PLANNING BOARD REPORT PORTLAND, MAINE

Level III Site Plan, Subdivision and Conditional Use
300 Allen Avenue
Administrative Authorization and Conditional Use Applications
PL-000012-2018, CU-000014-2018
Estelle Estates, LLC, Applicant

Submitted to: Portland Planning Board: Public Hearing Date: September 25, 2018	Prepared by: Matthew Grooms, Planner Date: September 20, 2018
---	--

Figure 4: Final proposed site plan

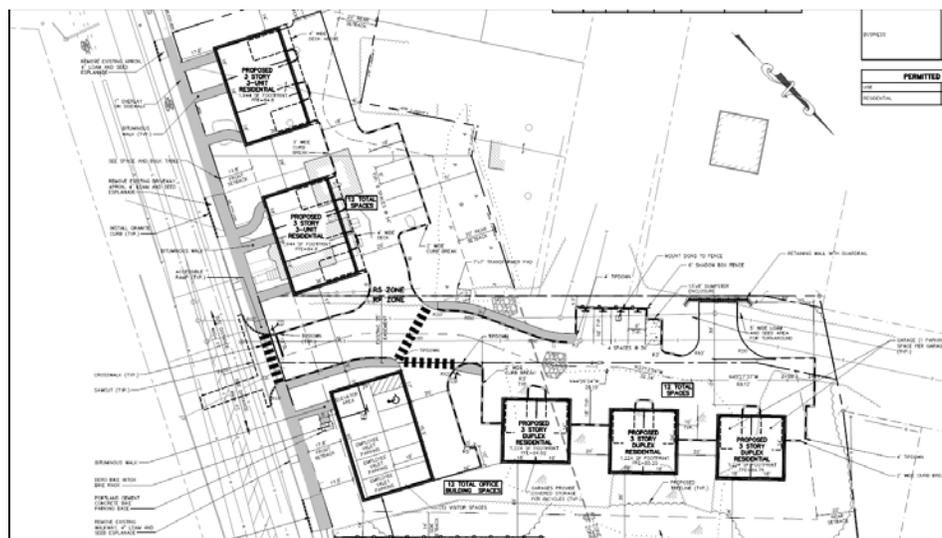
- The applicant should provide an opinion on the location of the driveway as it relates to the Allen Avenue cross-section and the transition from a two-lane section to a three-lane section.

- Sight distance from the driveway shall be provided.
 - Status: The requested information has been provided and I have no further comment.
 - Crash data for Allen Avenue in the vicinity of the project should be provided with a safety analysis of conditions.

1. Transportation Standards
 - a. Impact on Surrounding Street Systems and Access and Circulation- Tom Errico, P.E. with T.Y. Lin, has reviewed the proposal for compliance with city standards related to access and circulation and has provided the following comments:
 - A pedestrian sidewalk shall be provided between the Duplex buildings and Allen Avenue
 - Status: The plans have been revised and I have no further comment.

- Status: The applicant has indicated that the Allen Avenue Paving project is shifting the three-lane section towards Washington Avenue and the driveway will not be located in a transition area. I find conditions to be acceptable and have no further comment.

- The applicant reviewed crash data and there are no high crash locations in the vicinity of the project. I have no further comment.
 - A trip generation estimate shall be provided.

- The applicant has estimated the project will generate approximately 20 to 23 trips during the AM and PM peak hours. This level of traffic is not expected to create safety or capacity problems. I have no further comment.

Figure 8: Proposed triplex elevations

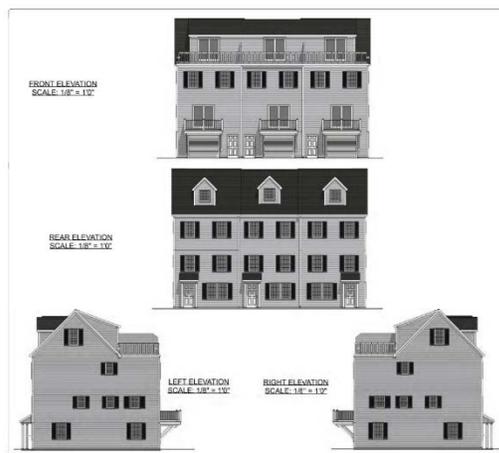
Residential Buildings – no change since Workshop

- The established residential character uses articulation and massing elements such as gable and hip roofs, elevated ground floor, bay windows, extended porches, and overhanging eaves and cornices. To this end, the gable roof, shingle siding, shutters, and covered entries are appropriate. However, additional elements such as extended porches, bay windows, elevated entry, or similar would make the architecture more similar to the surrounding fabric – applicant is constrained by the setback requirements and has not been able to add bay windows or extended porch for that reason.

- The building and front doors have a direct relationship to the street similar to the other houses nearby.
- The slope of the roof was revised to be more comparable to the context. The gable dormers now have windows in response to staff comment.

- Parking areas are placed away from the street and should be screened from abutting properties according to this standard as well as the Site Plan standards.
